UNITED STATES PATENT AND TRADEMARK OFFICE

APPLICATION NO.	FILING DATE	FIRST NAMED INVENTOR	ATTORNEY DOCKET NO.	CONFIRMATION NO.
10/601,040	06/20/2003	Wayne Jacob Gregoire		7169

Office Action Summary

DETAILED ACTION

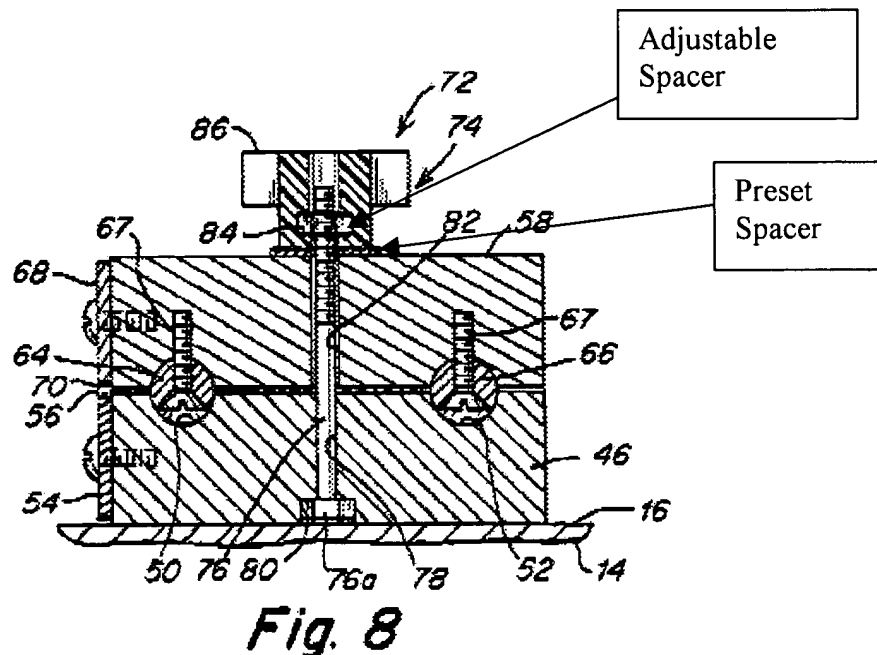
With regard to claim 15 as best as can be understood, Jukoff discloses an indexing channel extrusion (50, 52) an indexing block (44, 46), a guide attachment (68), an adjustable indexing component (70) an extruded forms means of adjustment and indexing. Examiner notes

that the teeth (70) of the guide attachment (68) of the horizontal/guide (58) engage teeth (56) of the indexing track (44, 46) so as to position and adjust the horizontal/guide bar (58).
